ADDENDUM NO. 1

PROJECT: ITB WS 26-20
HIGHWAY 90 EAST WATER AND SEWER MAIN EXTENSIONS

OWNER: OKALOOSA COUNTY

DATE: March 11, 2020

2" SEWAGE AUTOMATIC AIR RELEASE AND VACUUM VALVE IN PRE-CAST 60" DOGHOUSE FLAT TOP MANHOLE OVER FORCE MAIN

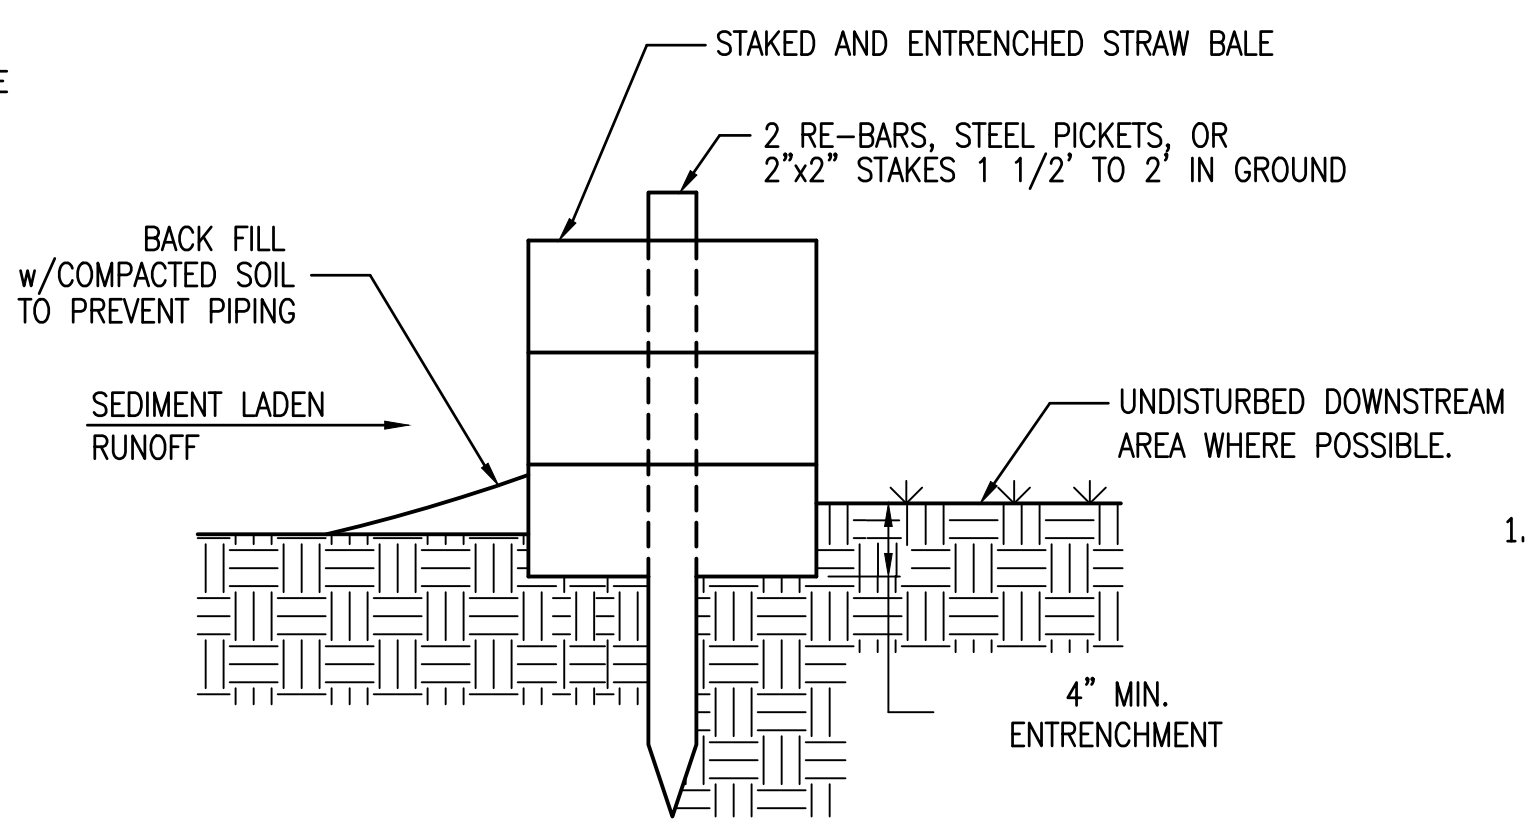
- NOTE – ARV Manholes are required to have aluminum access doors as specified in Item 2.2. Revised detail sheets depicting aluminum access door and 60" flat top manhole are included with this addendum.

- Please find enclosed a revised Index Sheet (G-01) and revised detail sheets C-45 & C-46. Revised sheets C-45 & C-46 shall hereby replace sheets C-45, C-46 & C-47 in their entirety.
 - The revised sheets consolidate the details sheets, remove references to detector wire in the details, and clarify ARV manhole and hatch requirements.

- Question: The specs call for a 48"x54" hatch for ARVs. Would a 48"x48" hatch be acceptable?
 - Answer: Yes, the detail sheets and specs are updated with this addendum and include a 48"x48" hatch.

- Section 33 05 13.02 - Precast Concrete Manholes for ARV's, Item 2.2.A on page 33 05 13.02 – 2 is hereby revised as follows:
 - Aluminum access doors shall be double leaf 48" x ~~54"~~ **48"** aluminum access hatch. Door leafs shall be minimum ¼" aluminum pattern plate reinforced with an H-20 load rating. Cover shall be equipped with a flush lifting handle and 316 stainless steel hold-open arm with a vinyl grip that automatically locks the cover in the 90-degree open position. Frame shall be extruded aluminum with an integral seat and continuous anchor flange on all four sides. Hinges shall be 316 stainless steel hinges with 316 stainless steel tamper-resistant bolts/locknuts. Latch shall be 316 stainless steel slam latch with plug and removable key wrench. Cover and frame shall be mill finish aluminum. Hardware shall be 316 stainless steel. USF Fabrication Model AHD or approved equal.
